Technical Bulletin

TB5000-054

5000 Bodymaker

Coolant Solenoid Valve

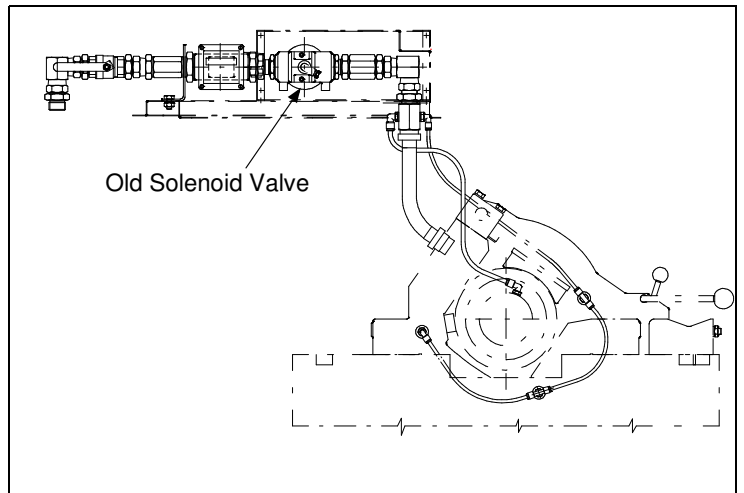
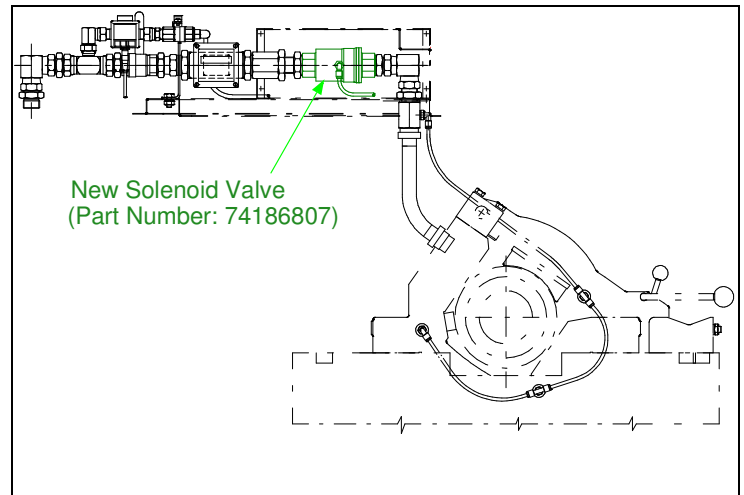
Summary: To ensure correct function and to tackle potential corrosion issues CarnaudMetalbox Engineering have, after working closely with various customers introduced a new Coolant Valve.

The new valve body and piston are made from Nickel plated Brass. The Seals, 'O' Rings and Gaskets are manufactured from Viton to combat a range of worldwide coolants. The internal components of the valve are of a more robust design giving significant improvement on working life.
